# 1ST & PIKE

103 PIKE STREET

EARLY DESIGN GUIDANCE 3  
03 APRIL 2018  
DPD #3028428

1. ARCHITECTURAL CONTEXT - SHADOW STUDIES - SUMMER

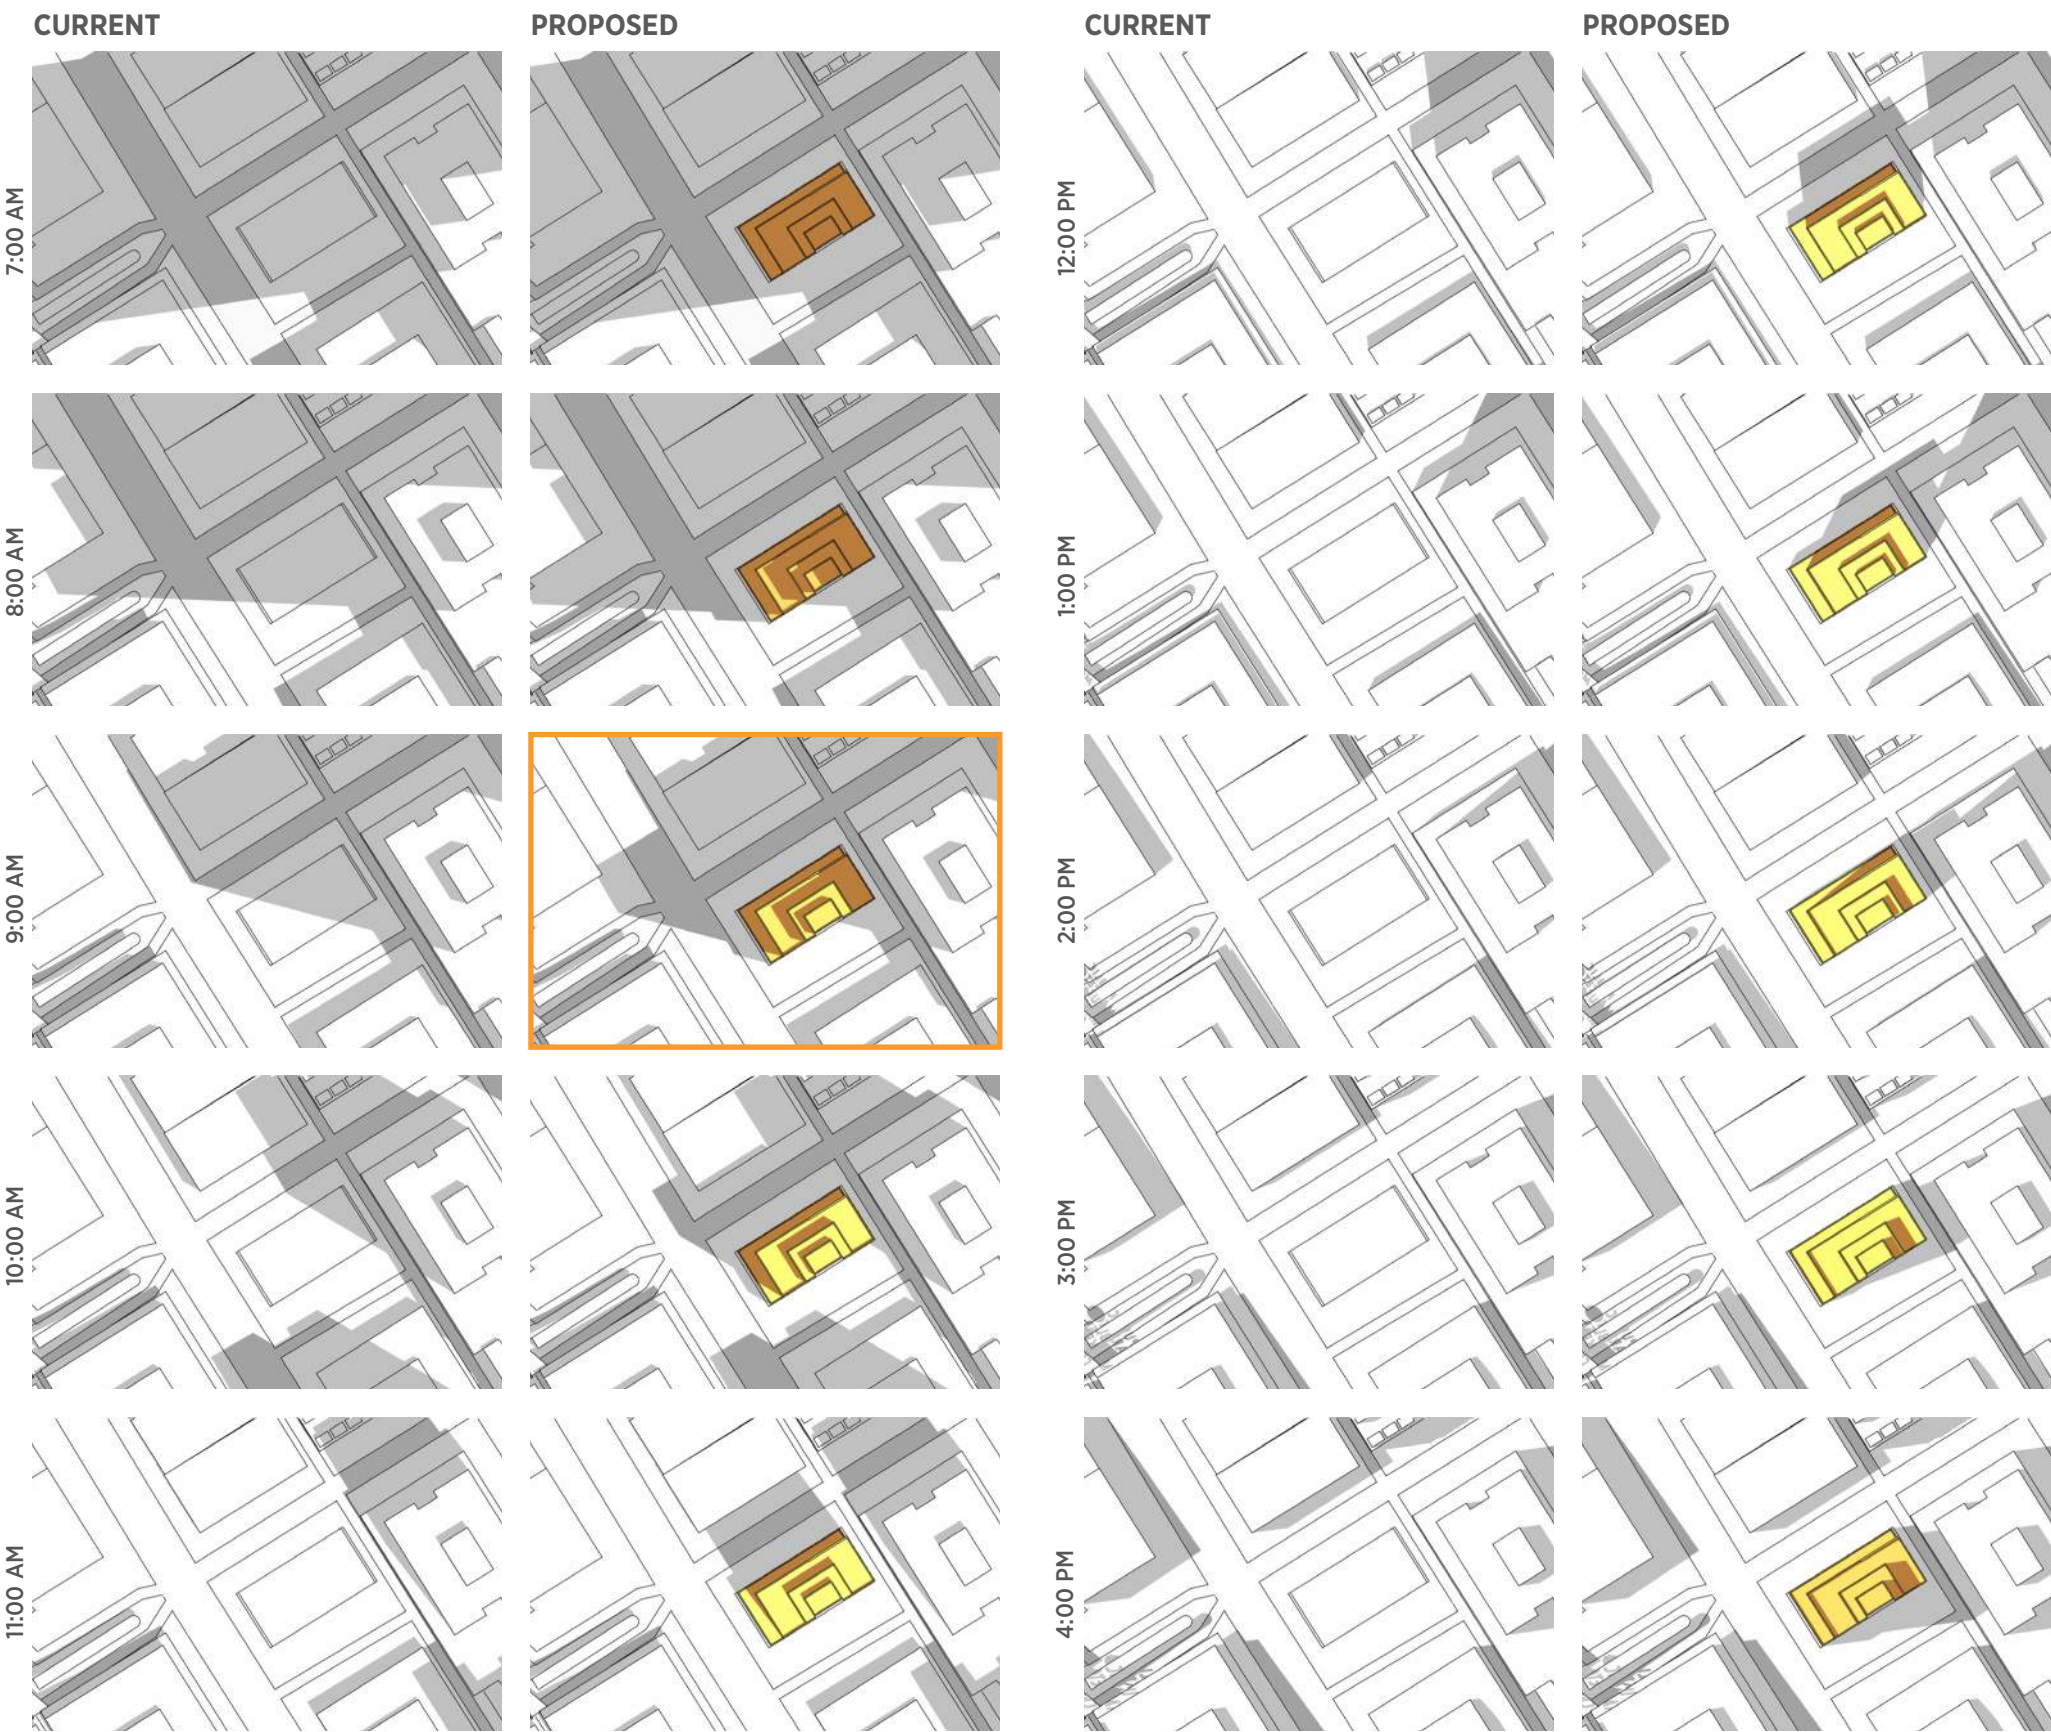
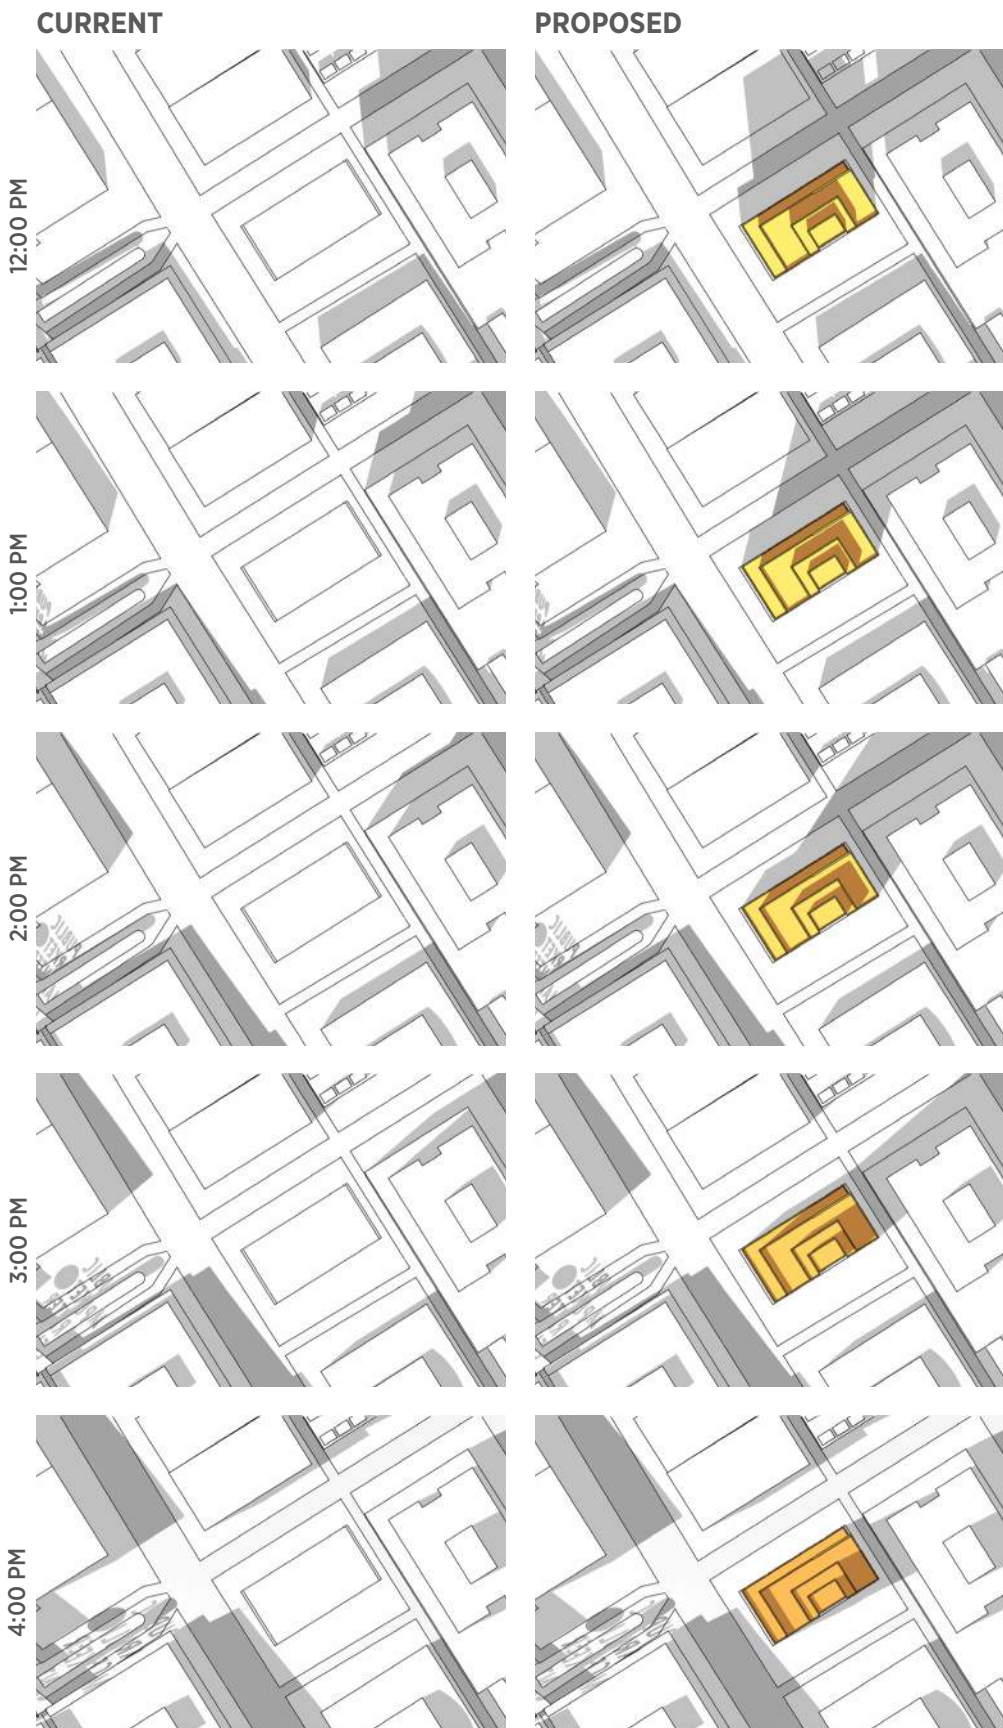
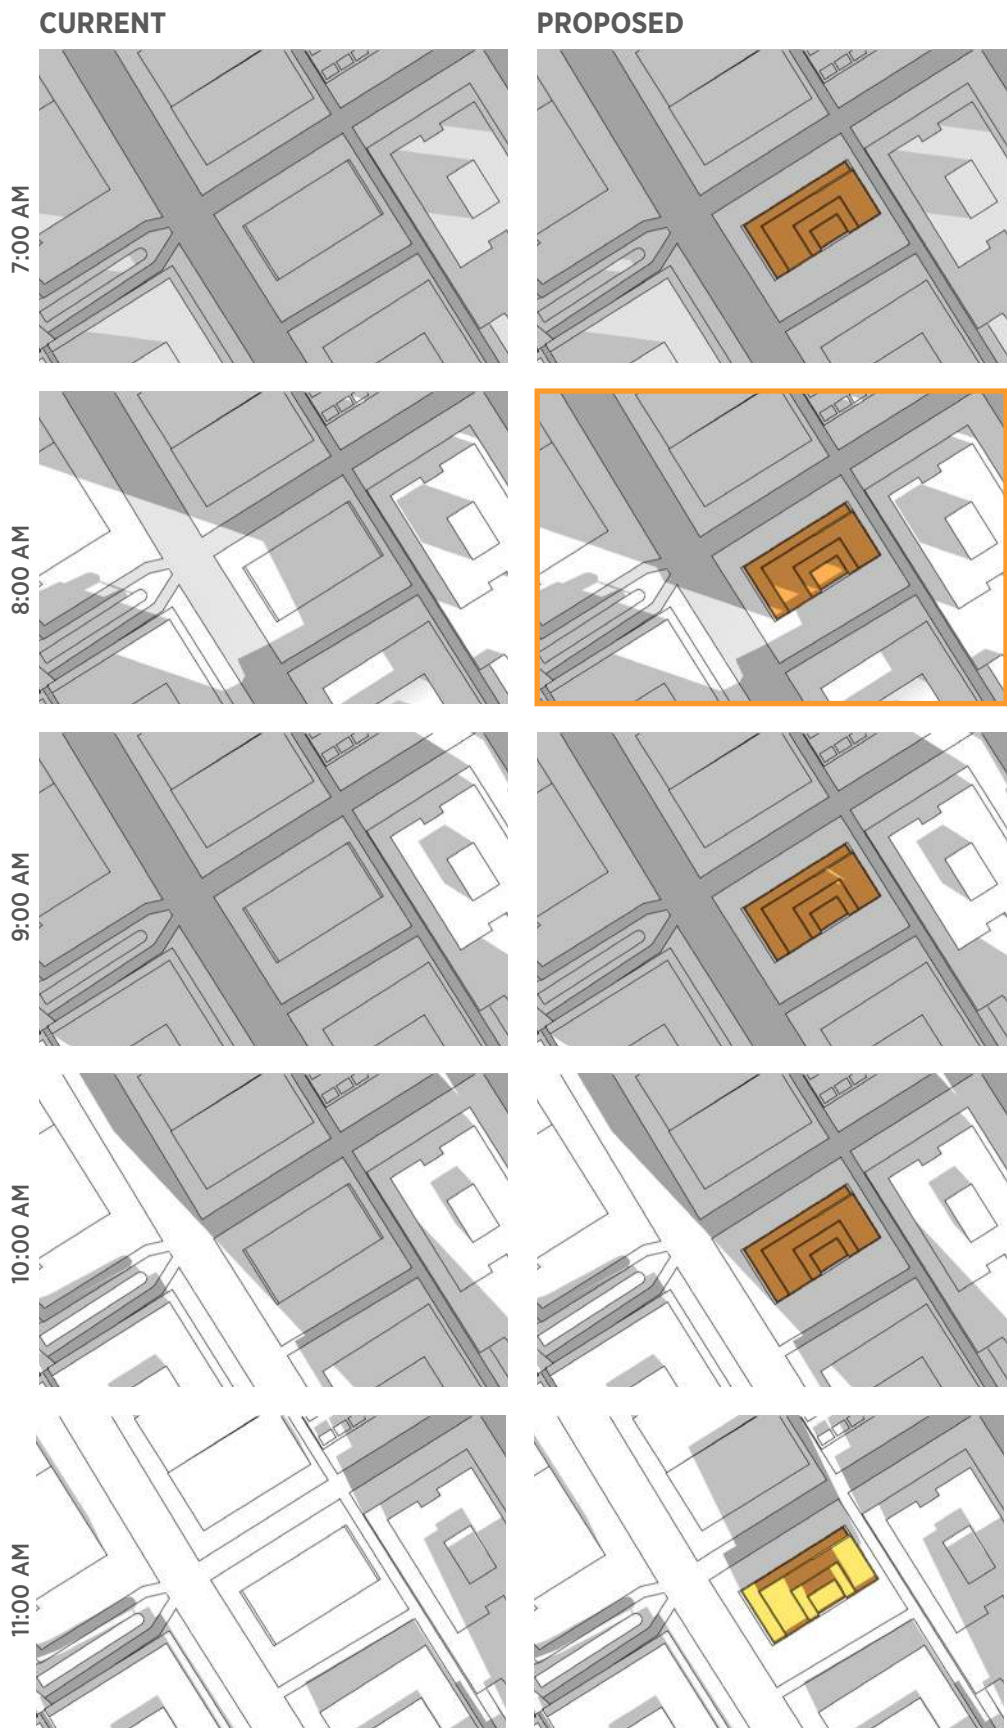
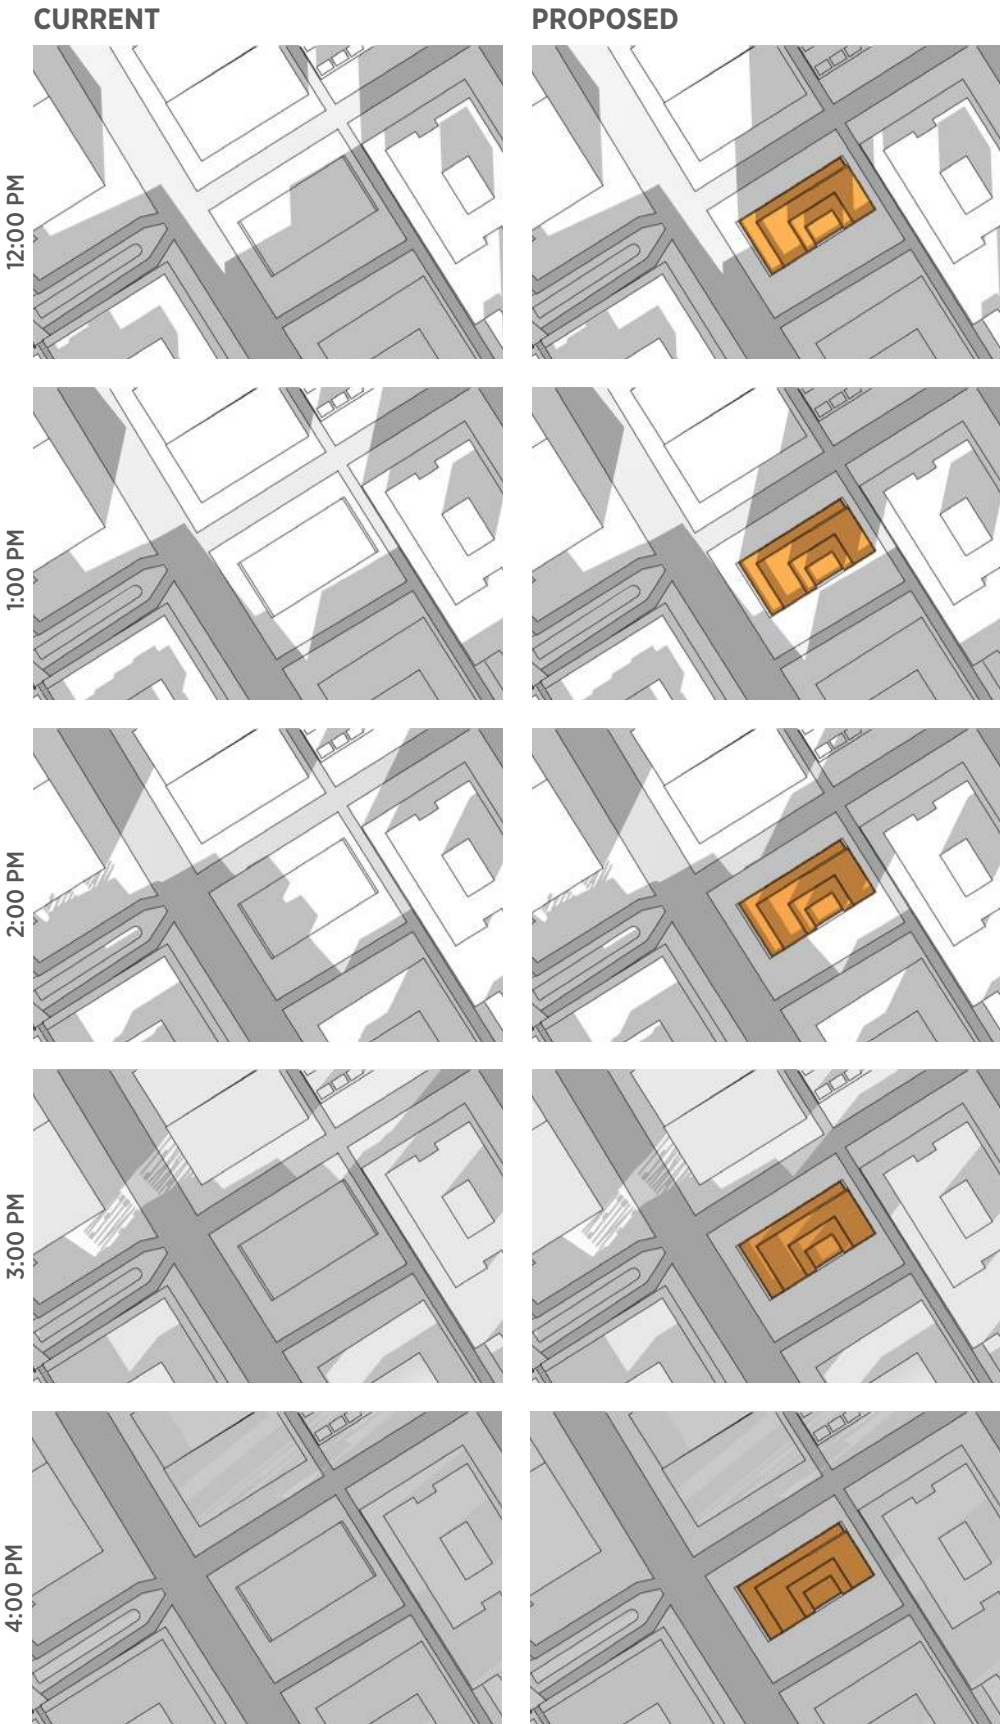
1.a.ii The Board requested an enhanced solar/shade study be provided and presented at the next EDG meeting , including information (early morning times) illustrating if and how long the design would cast shadow onto the Pike Place Market. The study should also differentiate between the existing shadow condition and forecasted shadow condition with the design's massing.

The team performed a solar/shadow study to understand the design's impact on the surrounding context. The analysis showed minimal shadows would be cast on the corner of Pike Place Market between 7-9 a.m. during the Spring and Fall Equinoxes. A small shadow would be cast on the sidewalk in front of the Corner Market building between 8-9 a.m. at Summer Solstice. Existing buildings are the primary contributors to the morning shadow. Times when there is a shadow cast have been highlighted in orange.
